#### TOWN OF NEWBURGH PLANNING BOARD REVIEW COMMENTS

PROJECT: CASSARA 3 LOT SUBDIVISION

PROJECT NO.: 14-06

Re: Antonio Cassara - Subdivision

## Typical Precast Concrete Distribution Box

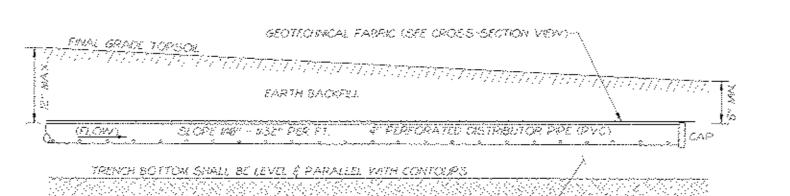
- 5. Percolation test data has been included on sheet 2.
- 6. The Sewage Disposal System Requirements Table on sheet 2 has been revised to specify the proposed two-family house contains one (1) 3-bedroom unit and one (1) 1-bedroom unit.
